**HISTORIC PRESERVATION REVIEW BOARD  
STAFF REPORT AND RECOMMENDATION**

Landmark/District:	<b>Capitol Hill Historic District</b>	<input checked="" type="checkbox"/> Agenda
Address:	<b>121 Tennessee Avenue, NE</b>	<input type="checkbox"/> Consent
Meeting Date:	<b>July 26, 2018</b>	<input checked="" type="checkbox"/> Concept
Case Number:	<b>18-430</b>	<input checked="" type="checkbox"/> Alteration
		<input type="checkbox"/> New Construction
		<input type="checkbox"/> Demolition
		<input type="checkbox"/> Subdivision

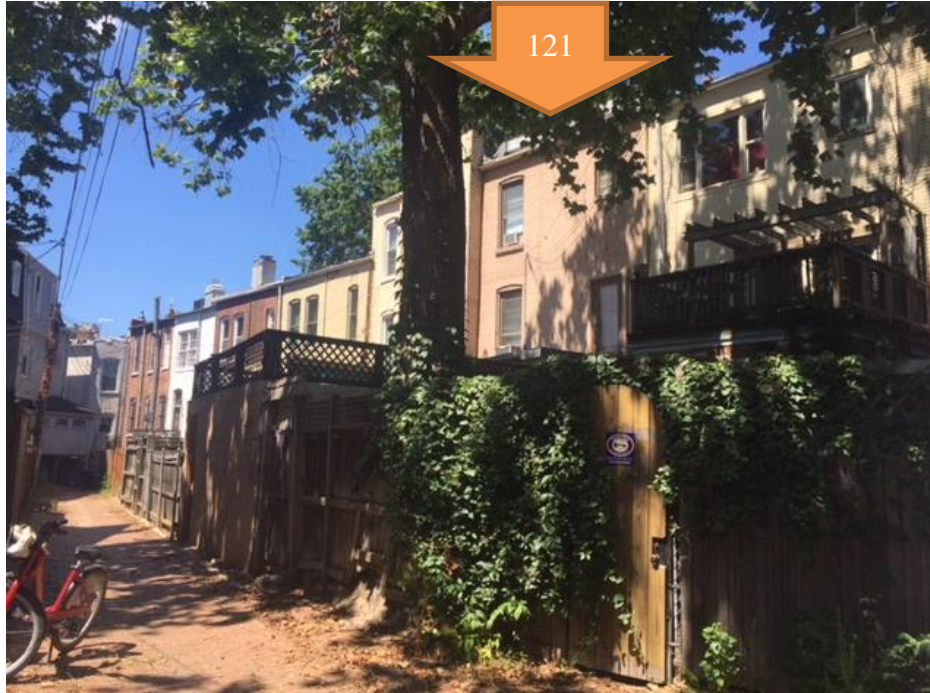
The plans call for construction of a two-story addition above the existing one-story wing. The addition would conform to the footprint of the existing wing except for a slight cantilever at the northern side-court elevation. The rear and courtyard elevations would be clad in vertical cement board siding and feature regularly bunched window opening. The south side elevation would be clad in brick and feature no fenestration.

The Board has traditionally given flexibility for additions on secondary rear elevations to allow for adaptation of houses to contemporary use, particularly when as in this instance they are not visible from any public street. The proposed addition will closely conform in footprint to the existing one-story wing and will not extend the full width of the building, and the additional floors will not impact or eliminate significant architectural features of the building. More than half the buildings within the square feature rear wings ranging in height from one to three stories. 121 Tennessee has the second deepest lot within the block and the additional two-floors will not overwhelm the alley-scale or the adjacent neighbors. The proposed use of Hard-plank at the third floor will differentiate the addition from the existing one-story wing and allow the building's historic volume to remain legible.

*The HPO recommends that the Board find the concept to be compatible with the historic district and to delegate further review to staff.*
